AGENDA

4. Recommendation to review and approve the 140 West 2nd Design Review Application P24-092.
ADJOURNMENT:

The applicant is proposing to develop a new 9,363-gross-square-foot mixed-use building located at 140 W 2nd Street (the “subject property”) in the Mixed-Use Subdistrict of the Community Core (“CC-2 Zone”). The project includes an art gallery and showroom space on the ground level, two multi-family dwelling units on the second floor, and a residential penthouse on the third floor (see Figure 1). Four

AREA PLANS AND CALCULATIONS

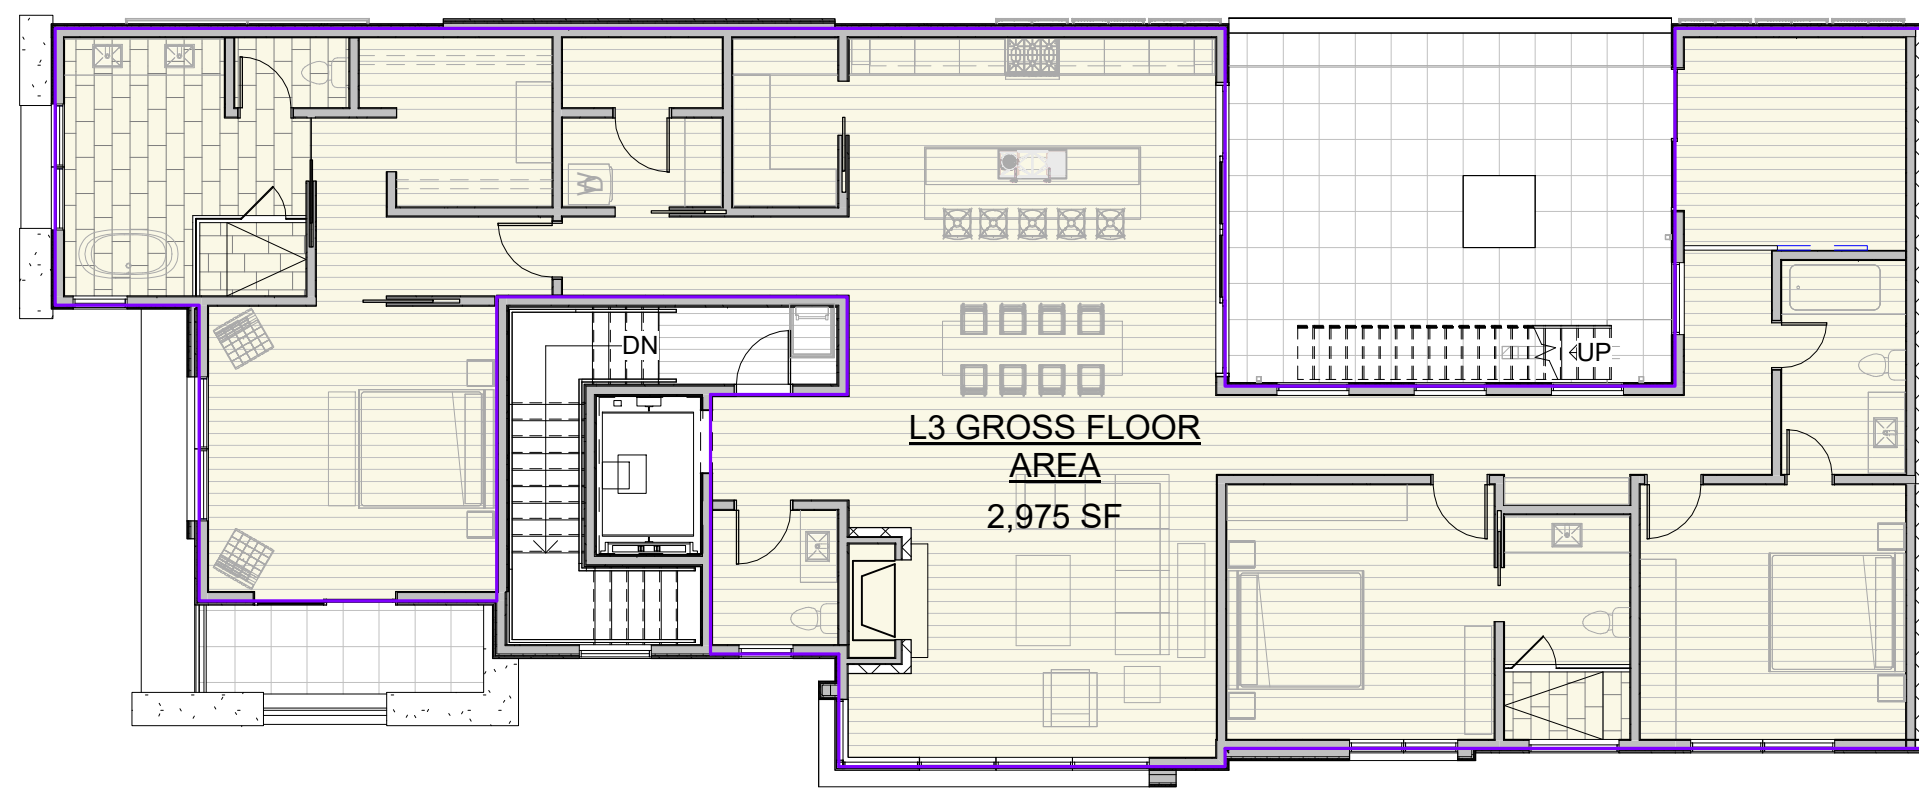
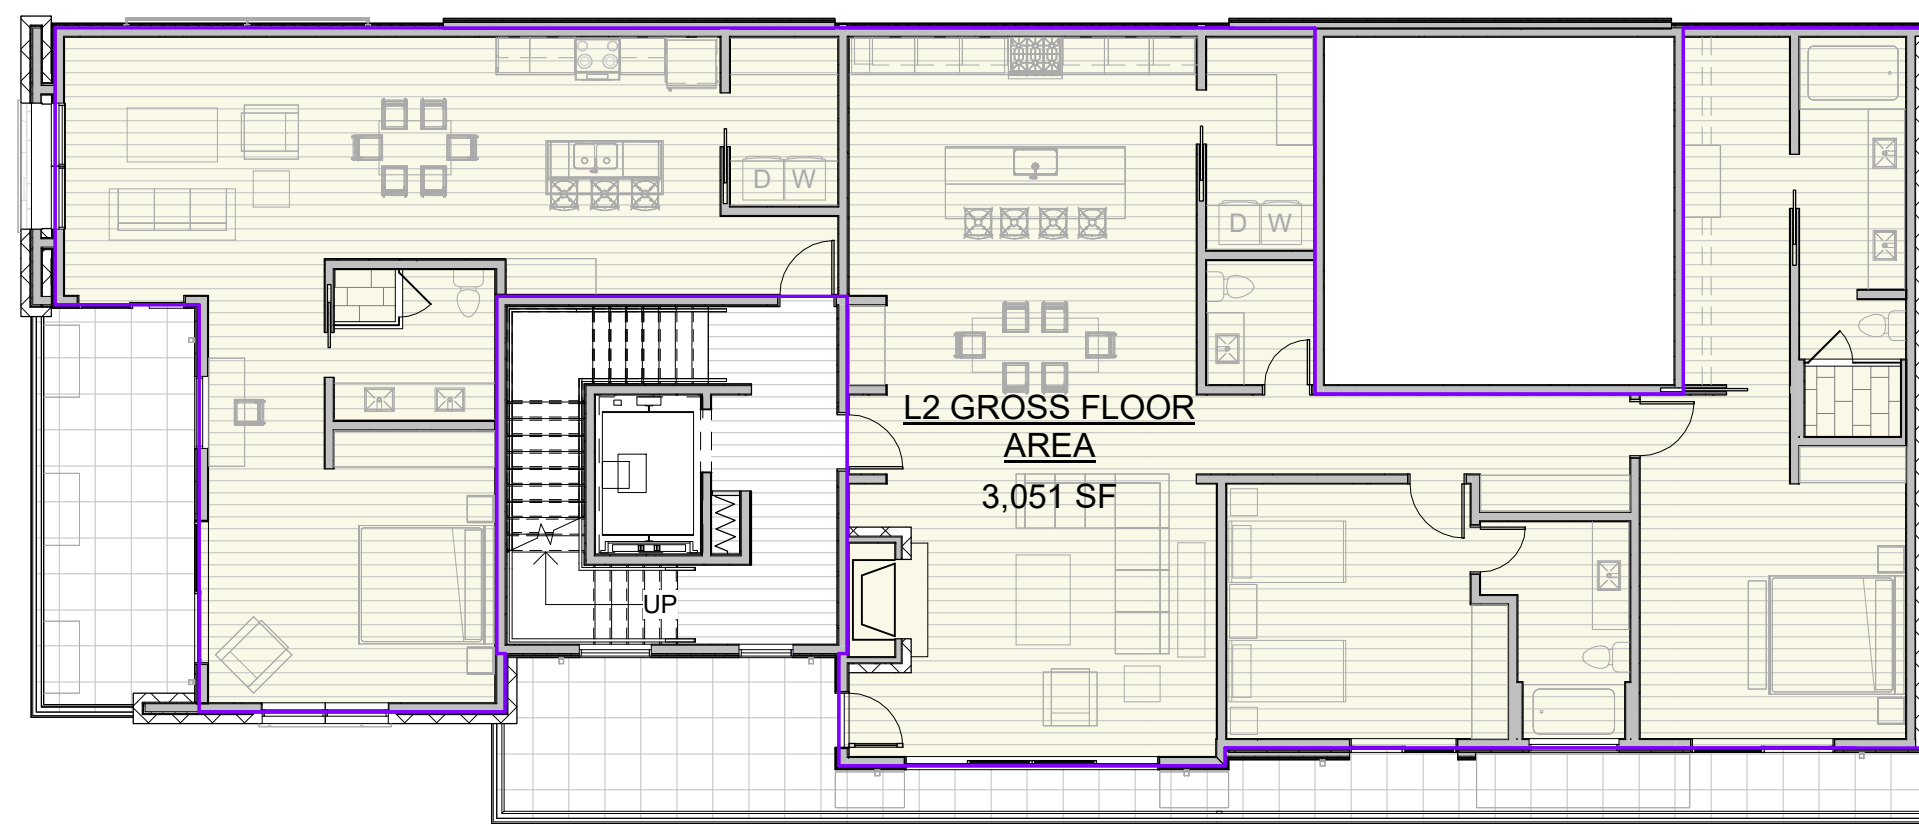
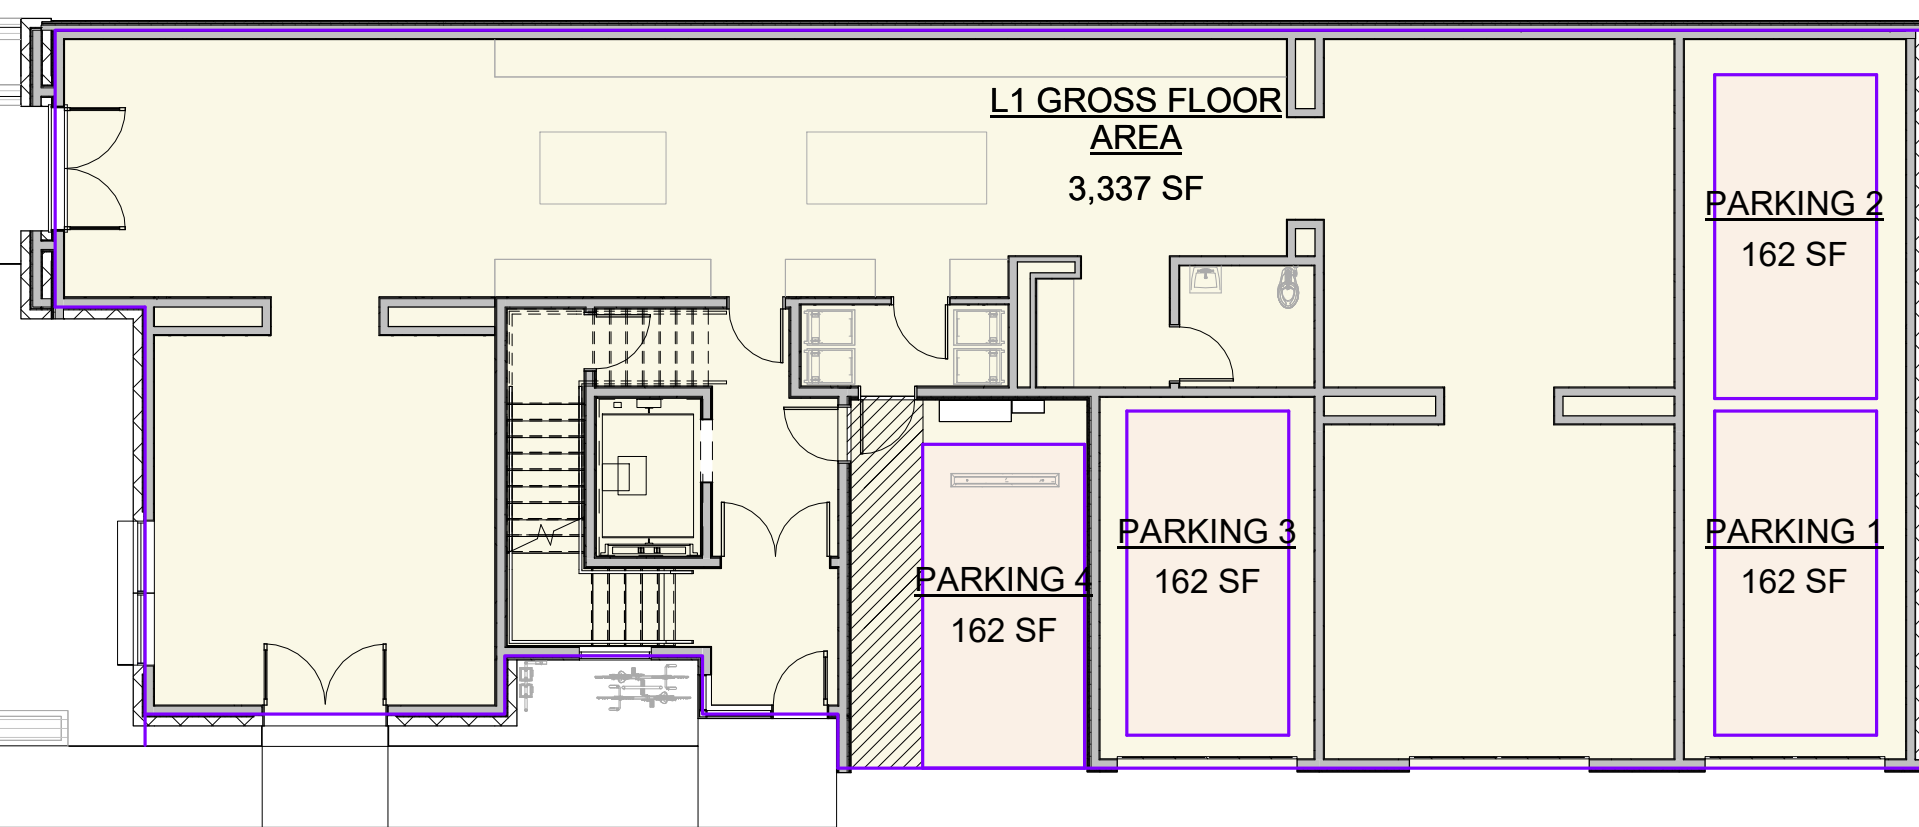
Project net and gross floor area calculations are provided on sheet A-010 of the project plans.

EAST ELEVATION - DESIGN REVIEW

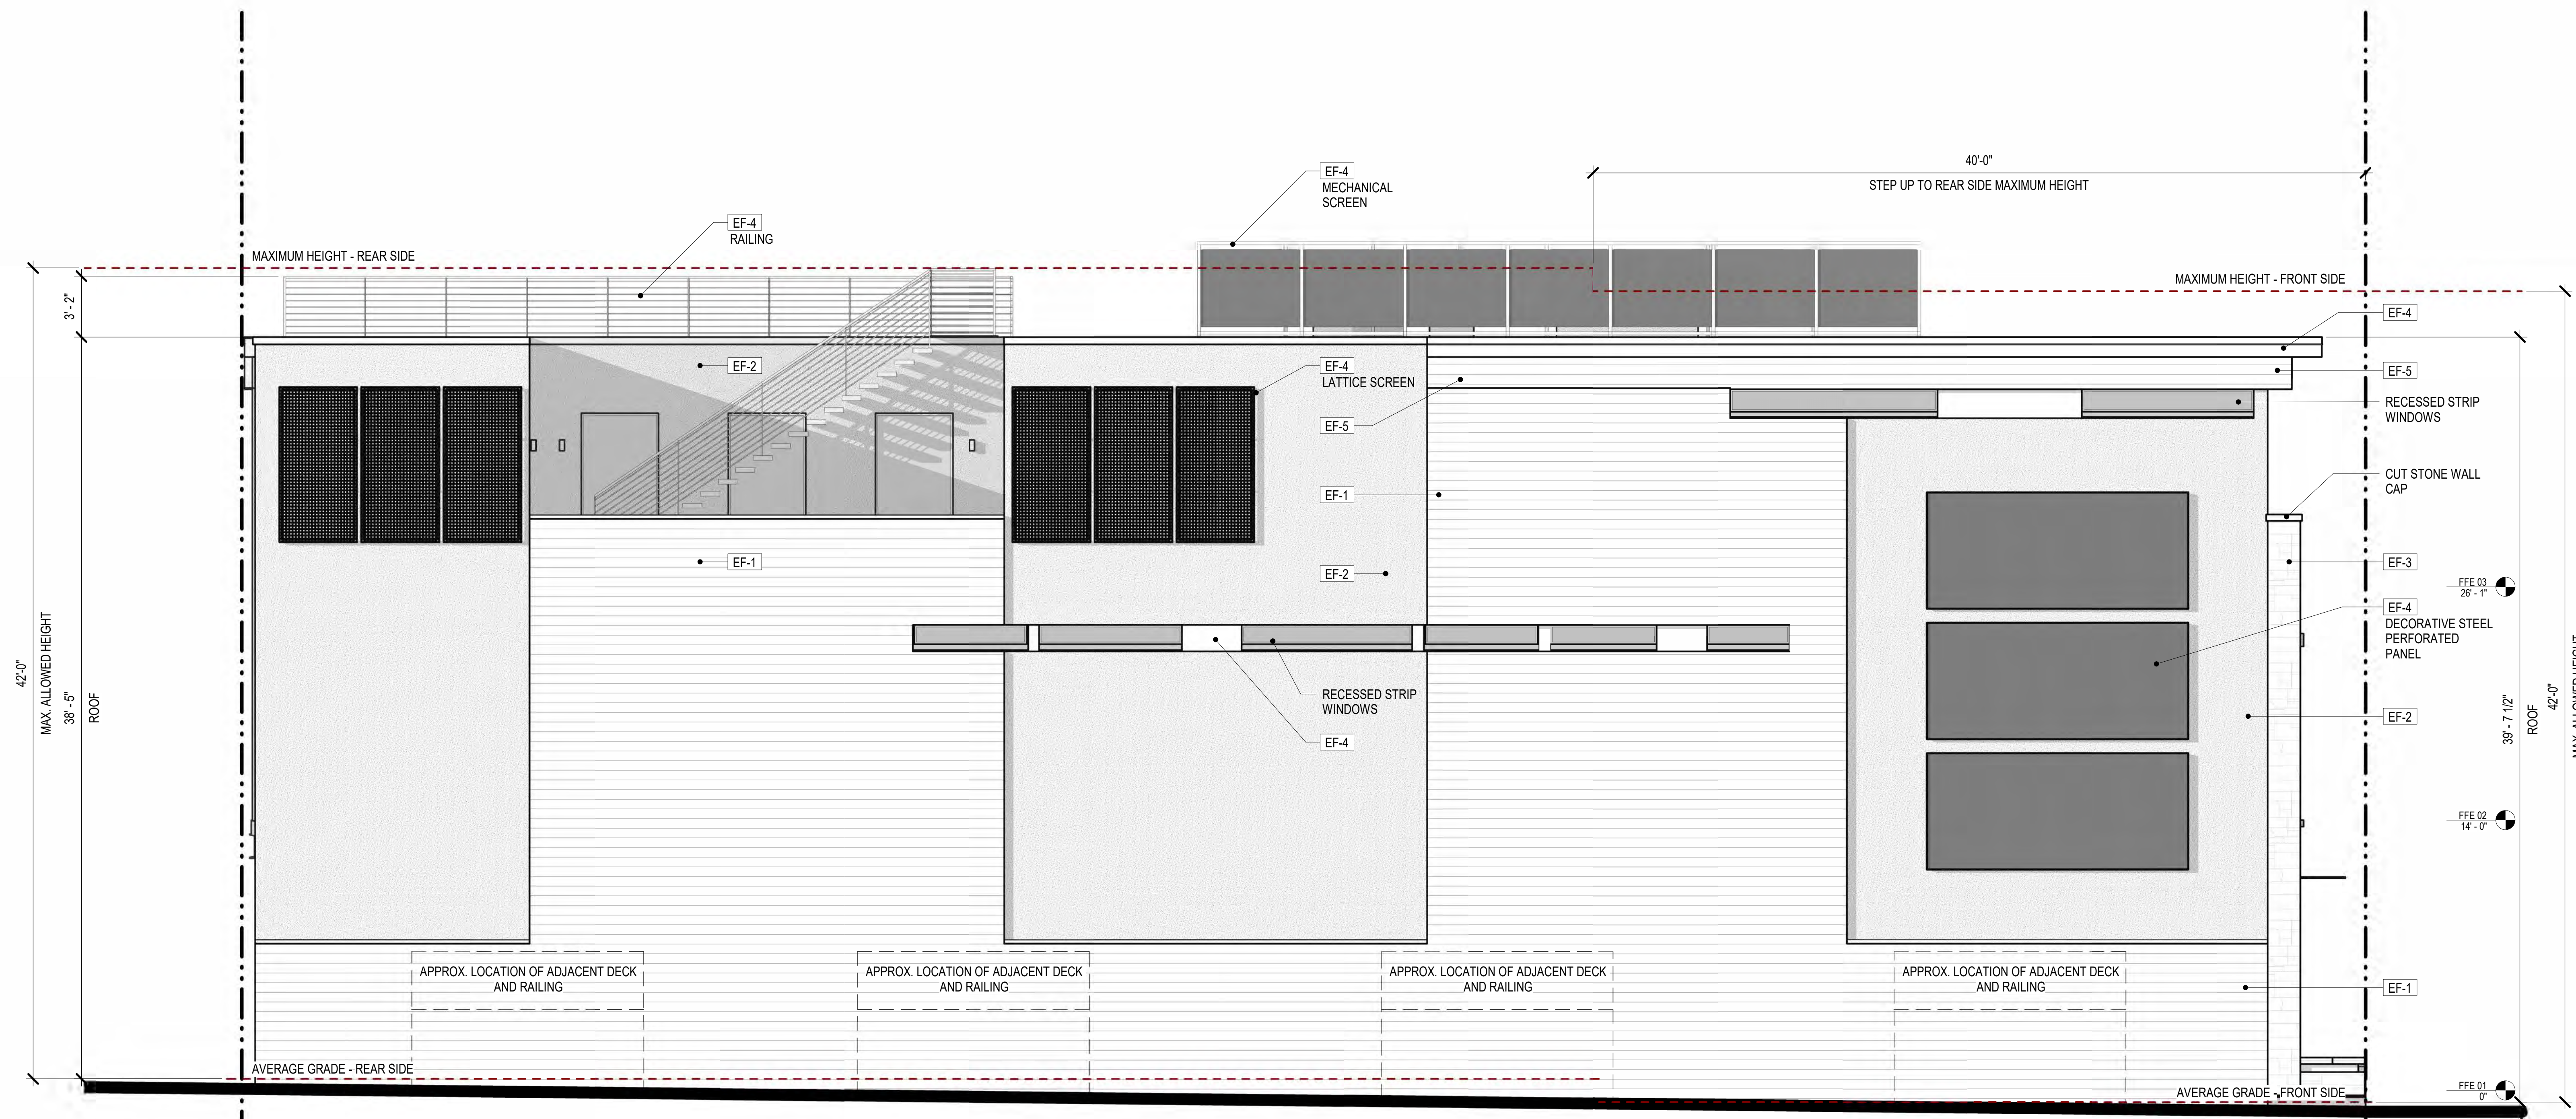
The proposed development is setback 2.5 inches from the east side property line and the three-story east side wall is directly adjacent to residential units on the ground floor of the Galena Building. The three-story east side wall is directly adjacent to decks attached to the rear of the Galena Building. During their review of the Pre-Application, the Commission provided recommended the applicant consider design treatments to soften the impact of the east side wall and add visual interest. As shown in Figure 7, the applicant has modified the design of the east side wall by adding recessed strip windows, steel lattice screens with vines, and decorative perforated metal panels. In addition, the applicant modified the design of the roof soffit to wrap around the building corner and extend along the top of the east side wall. Staff believes the applicant's design modifications softens and adds visual interest to the east side wall.
